Why cumulativeScaledRateOffset is important - and needs to remain a mandatory feature

Christian Boiger
christian.boiger@b-plus.com
IEEE 802.1 Interim
May 2015
Pittsburgh, PA

Example 1

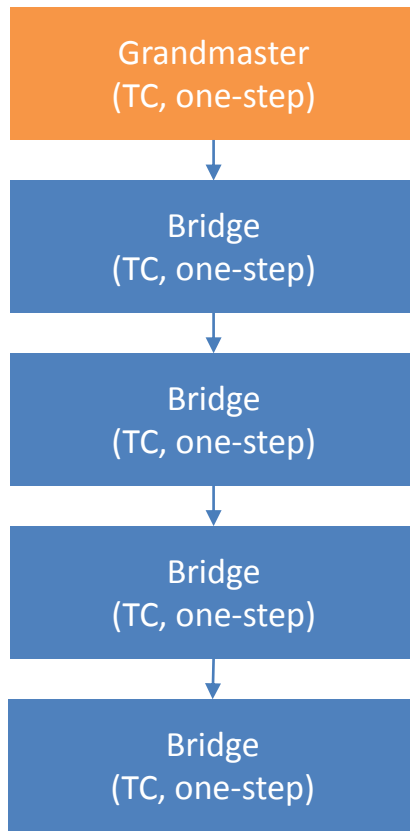
Neighbor Rate Ratio	Rate Ratio relative to GM	cumulativeScaledRateOffset	Residence Time	Accumulated Error*
N/A	N/A	0 ppm	N/A	N/A
+100 ppm	+100 ppm	0 ppm	400 μ s	40 ns
0 ppm	+100 ppm	0 ppm	400 μ s	80 ns
0 ppm	+100 ppm	0 ppm	400 μ s	120 ns
0 ppm	+100 ppm	0 ppm	400 μ s	160 ns

Example 1: Rationale for the chosen values

In this example the worst case frequency offset between any system is 100 ppm. According to IEEE 802.1AS the worst case is 200 ppm.

In example 1 a residence time of 400 μs is chosen.

Assuming a 100 Mbit/s AVB network this is less than a maximum frame followed by a maximum burst of class A AVB frames (this would total to almost 500 μs).

Example 2

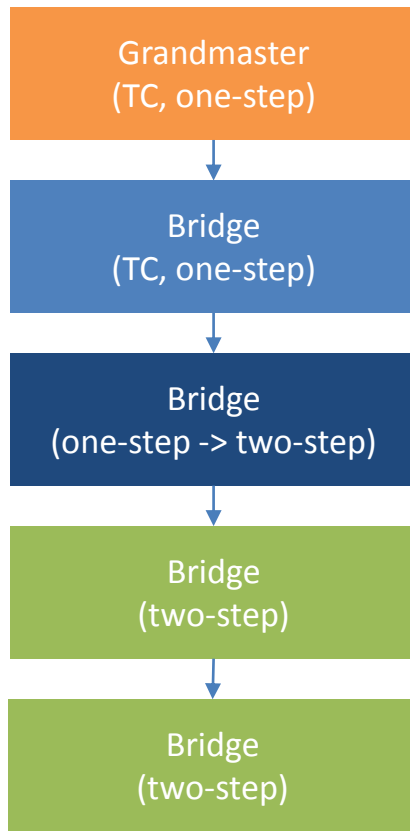
Neighbor Rate Ratio	Rate Ratio relative to GM	cumulativeScaledRateOffset	Residence Time	Accumulated Error*
N/A	N/A	0 ppm	N/A	N/A
+100 ppm	+100 ppm	0 ppm	400 μ s	40 ns
-100 ppm	0 ppm	- 100 ppm	10 ms	960 ns
0 ppm	0 ppm	- 100 ppm	10 ms	1960 ns
+100 ppm	+100 ppm	0 ppm	10 ms	2960 ns

Example 2: Rationale for the chosen values

In this example the worst case frequency offset between any system is 100 ppm. According to IEEE 802.1AS the worst case is 200 ppm.

IEEE 802.1AS-2011 requires a maximum residence time of 10 ms.

IEEE 802.1AS-Cor1 changes this “shall” to a “should”.

In case of generated Sync messages due to “missing Sync messages” the residence time can be > 125 ms.
